**TRAFFIC CONTROL SIGNAL SYSTEM, INTERSECTION
(VT ROUTE 100 & VT ROUTE 103)**
SEE TRAFFIC SIGNAL PLAN SHEET

PROJECT NAME: LUDLOW	PLOT DATE: 4/19/2017
PROJECT NUMBER: HES SGNL(44)	DRAWN BY: M. BOGACZYK
FILE NAME: t13b020_nul.dgn	CHECKED BY: P. COBURN
PROJECT LEADER: P. COBURN	SHEET 14 OF 43
DESIGNED BY: M. BOGACZYK	
PLAN SHEET 3

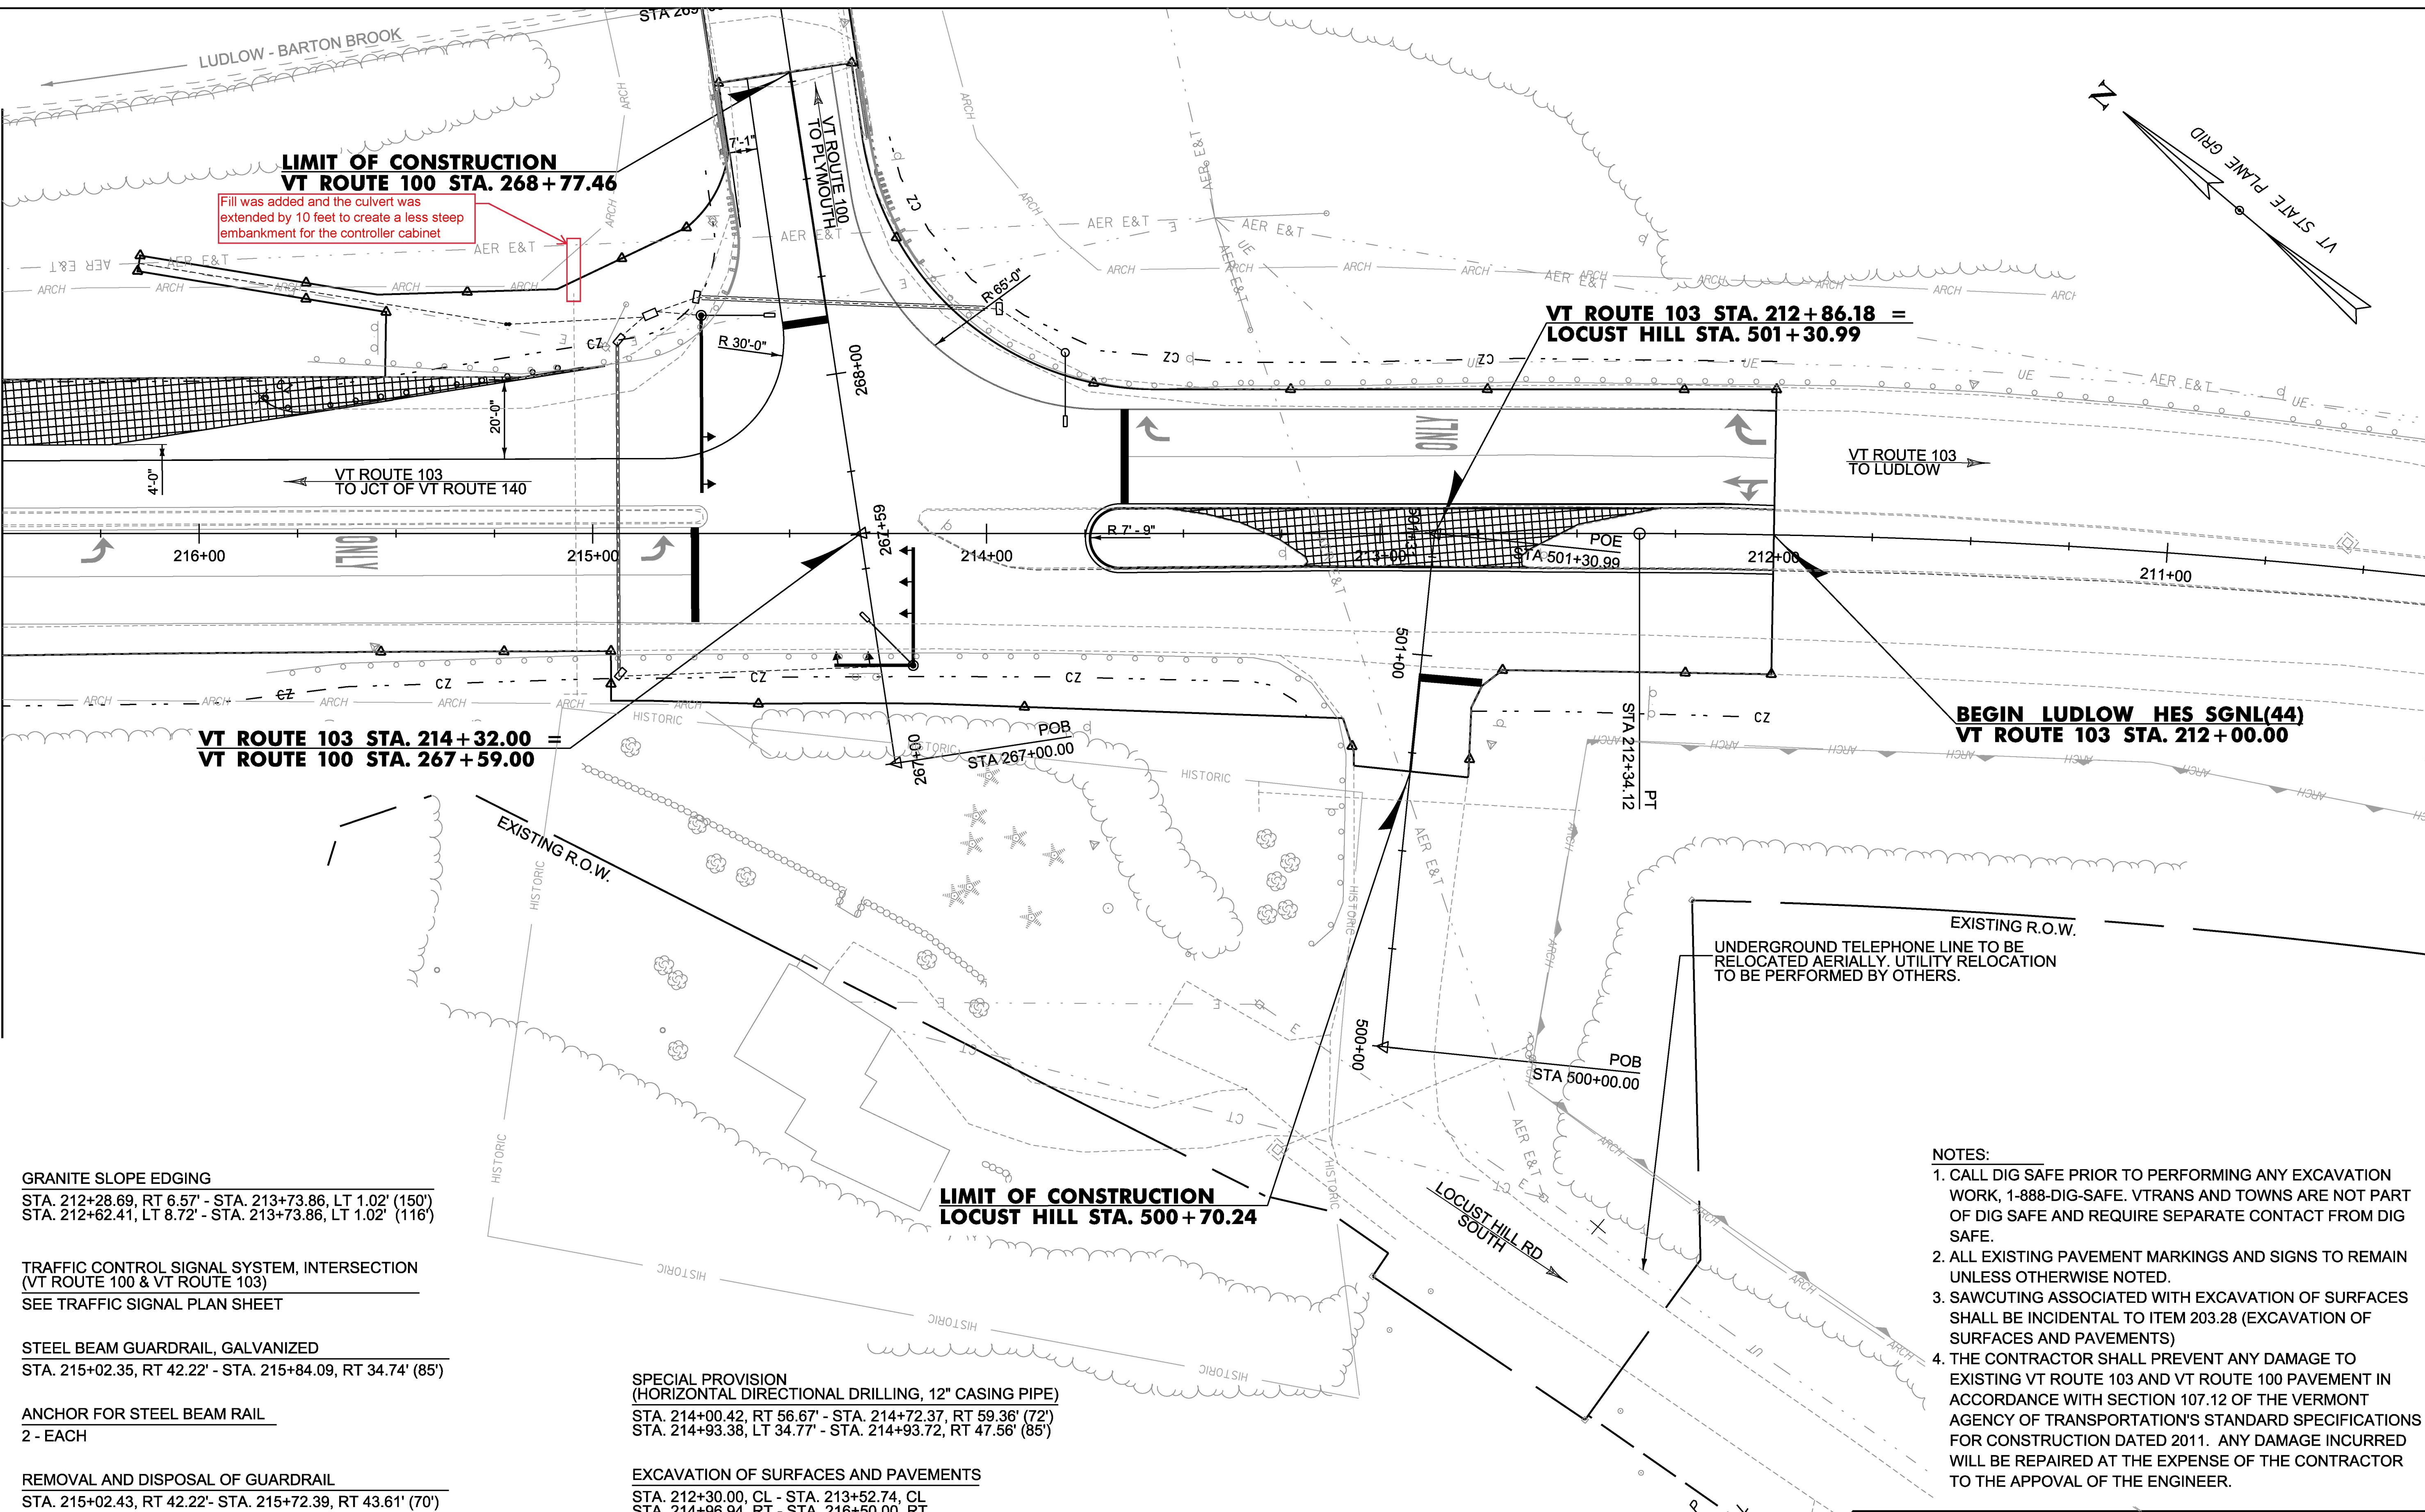
Fill was added and the culvert was extended by 10 feet to create a less steep embankment for the controller cabinet
